Redlines Completed 7-May - DP

## Lot 20 - Heritage at Neills Creek

# The Brunswick English Country- RH

STRUCTURAL ADDENDUM
RICHT HAND
2 23-65-081

First Floor Plan - English

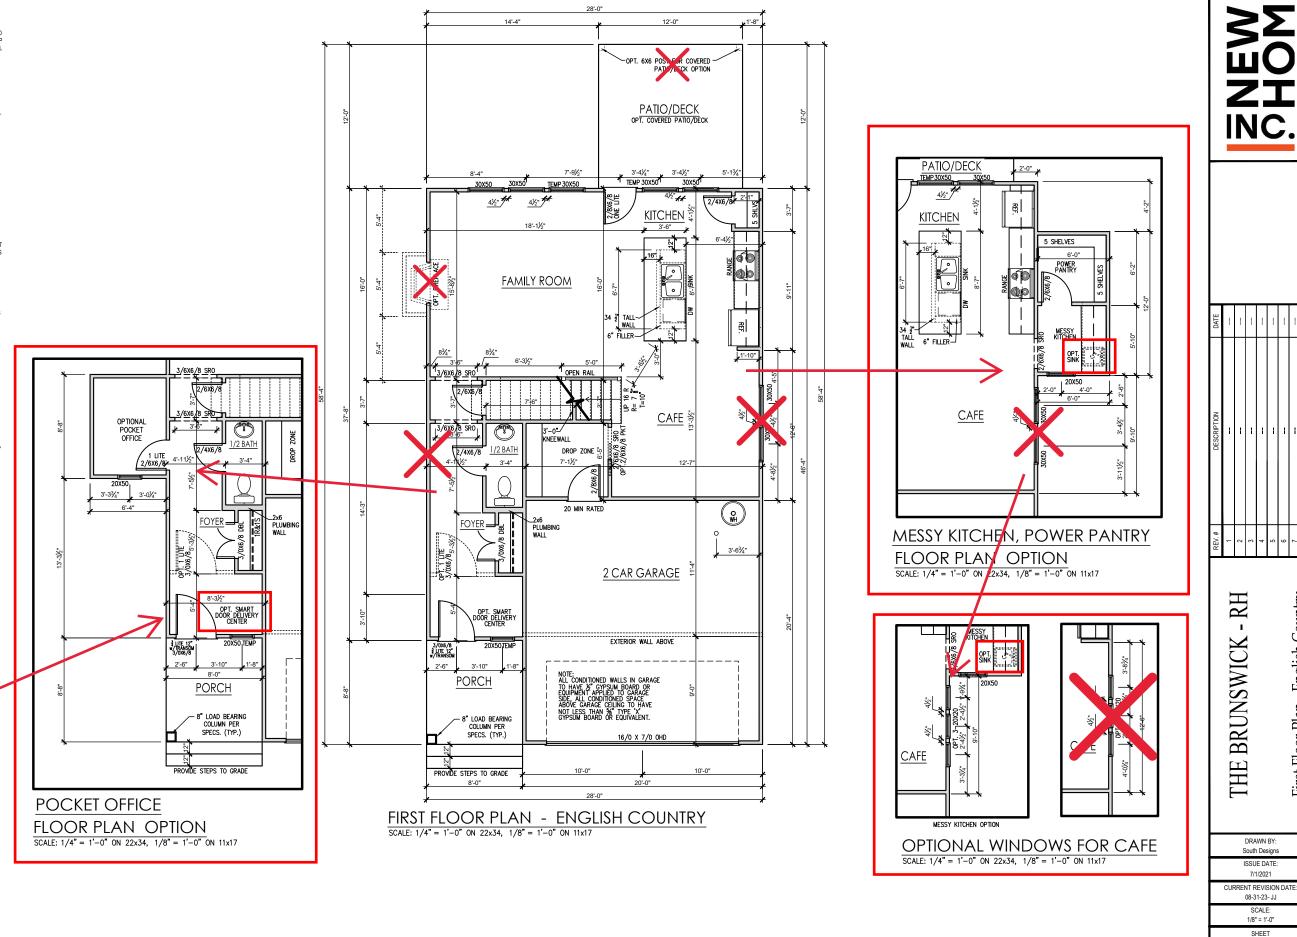
. CORRECT LABEL FOR OWNER'S CLOSET OPTION TO SAY OPTIONAL LARGER OWNER'S CLOSET.

Second Floor Plan 4

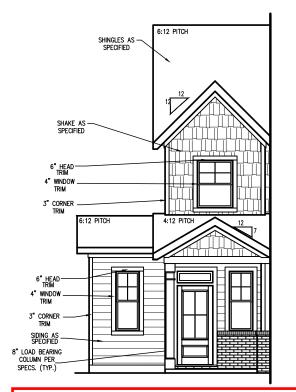
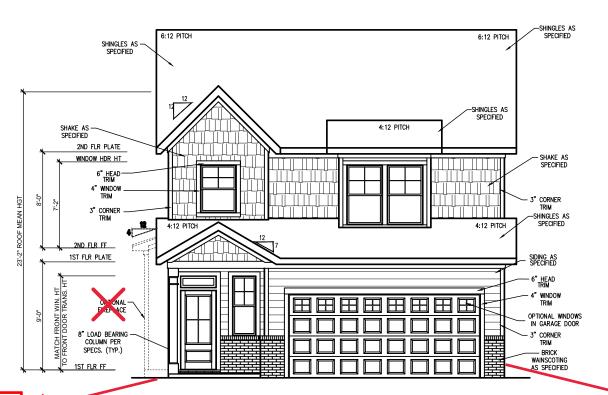
ADD OPTIONAL TO THE SECOND FLOOR PLAN WITH 3 BEDROOMS.
